Before the
FEDERAL COMMUNICATIONS COMMISSION
Washington, D.C. 20554

Application of)
)
SPACE EXPLORATION HOLDINGS, LLC) Call Signs: S2983 and S3018
)
For Modification of Authorization for the) File No. SAT-MOD-20181108-00083
SpaceX NGSO Satellite System)
)

**FURTHER CONSOLIDATED OPPOSITION TO PETITIONS AND RESPONSE
TO COMMENTS OF SPACE EXPLORATION HOLDINGS, LLC**

DYNAMIC INTERFERENCE ANALYSIS FOR ONEWEB AND O3B NGSO SYSTEMS

Figure 1. Worst-Case Downlink Comparison for O3b Constellation

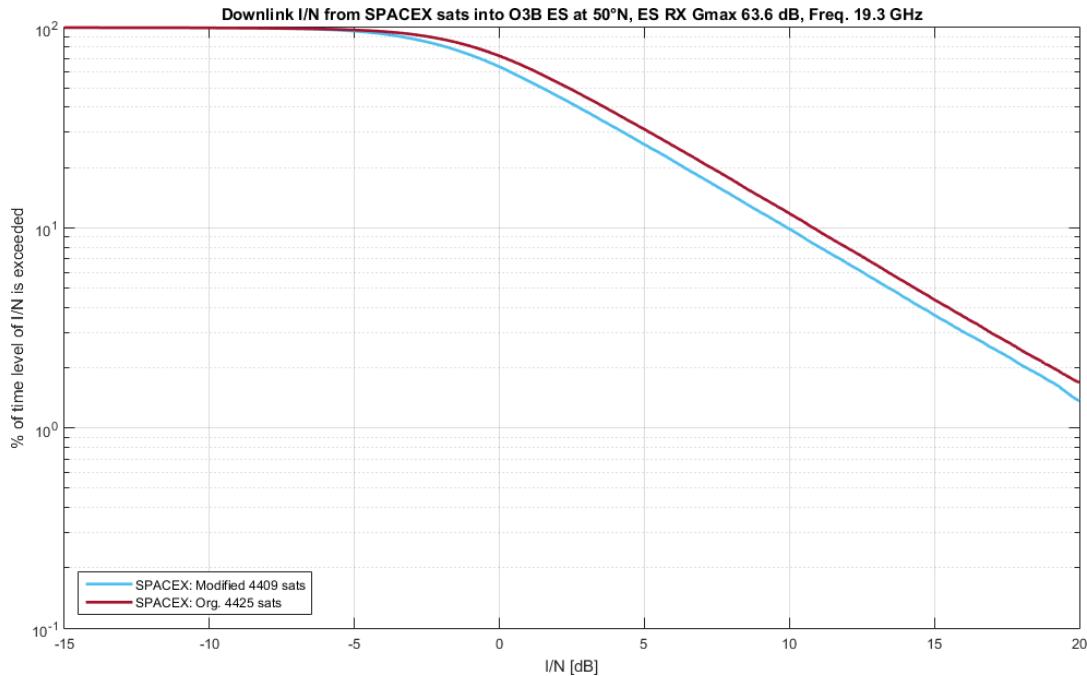
WorldVu Satellites Limited (“OneWeb”) and SES Americom Inc. and O3b Limited (“SES/O3b”) have criticized that analysis because it did not include a system involved in the Commission’s recent Ku/Ka-band processing round. In order to address this criticism, below we present a dynamic interference analysis to determine whether SpaceX’s constellation with the proposed modification would increase interference to the NGSO systems operated by OneWeb (in the Ku-band) and O3b (in the Ka-band). As before, the analysis examines both downlink and uplink interference and compares the impact on these victim systems of the original SpaceX constellation and the modified constellation.

The results of the analysis for a victim earth station of the O3b and OneWeb NGSO systems are set forth in Figures 1 and 2, respectively. In each case, the figure plots a CDF of aggregate I/N levels for the SpaceX constellation as originally proposed and as modified.
